RE: Submission to HumeLink Contingent Project Application Stage 2 application

The Centre for Independent Studies (CIS) welcomes the opportunity to respond to Transgrid's Contingent Project Application Stage 2 (CPA2) application for HumeLink.

Figure 1. Timeline of events surrounding the MCCA

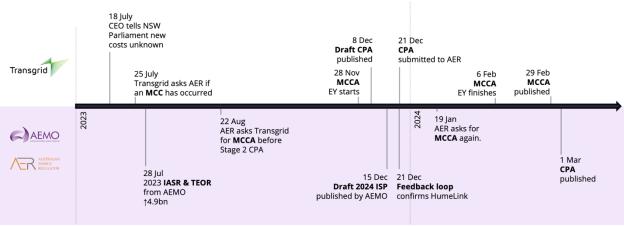
Transgrid's CEO previously testified before the NSW Parliamentary Committee on 18 July 2023 that the cost of HumeLink has increased by around 30%, while confirming a nominal dollar figure that would be closer to 50%. A week later, on 25 July, Transgrid wrote to AER asking if Transgrid needs to assess if a 'material change in circumstances' occurred in light of the cost escalation, as mentioned in AER's correspondence to Transgrid. **We note that Transgrid's**

Despite this, Transgrid completed their MCCA on 29 February 2024, nearly six months later. In addition, they submitted their Stage 2 CPA on 21 December 2023, 70 days prior to completing the MCCA; directly contradicting AER's directive that the NER required Transgrid to supply evidence of the MCCA prior to a CPA. This led AER to issue another notice to Transgrid on 19 January 2024, warning that the CPA is at risk of being non-compliant for not lodging the MCCA before submitting the Stage 2 application.¹⁸

Figure 2. Successive changes in HumeLink's Step Change scenario NPV²⁶

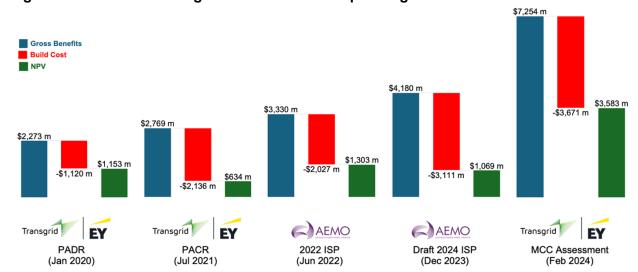
The 7.7x increase in NPV to \$3.58b under Transgrid's revised estimates is therefore a shock. It is also more than triple the \$1.07b NPV estimated by AEMO in the Draft 2024 ISP via the 'TOOT' analysis.²⁴ As EY notes in their Gross Market Benefit Assessment of Humelink, the significant difference in net economic benefits cannot simply be attributed to "the three-year difference in commissioning date and outlook period"²⁵ from the Draft 2024 ISP.

EY's Gross Market Benefit Assessment of HumeLink estimates a total discounted market benefit of \$7.25b, 74% more than the Draft 2024 ISP, and 161% more than the same model in the PACR. This significant change brings into question the reliability of the entire assessment.
